# Service Bulletin

## DCA400 Fuel Return Modification

<b>Product Group:</b> Power Solutions	<b>Date Issued:</b> 01/13/11	<b>Service Bulletin No.</b> GSP20110113
<b>Bulletin Type</b> <input checked="" type="checkbox"/> Mandatory <input type="checkbox"/> Information Only <input type="checkbox"/> Recommended Change		<b>Models/Series Affected:</b> <b>DCA400 SERIES</b> <b>TRAILER MOUNTED UNITS</b> <b>S/N 3838596 – 3842955</b>

### Details

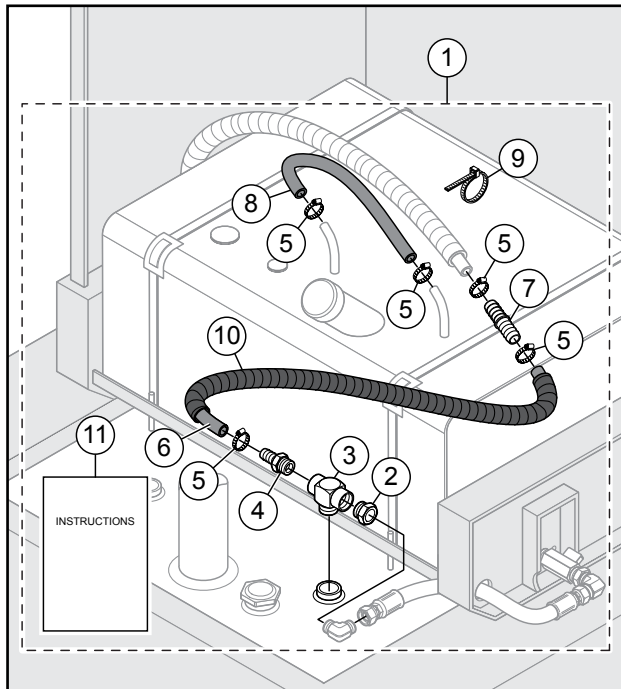
The engine return line delivers more fuel than can be displaced by the generator fuel tank to the trailer fuel tank, causing the generator fuel tank to overfill and leak fuel through the fuel tank cap.

Route engine fuel return line directly to the trailer tank.
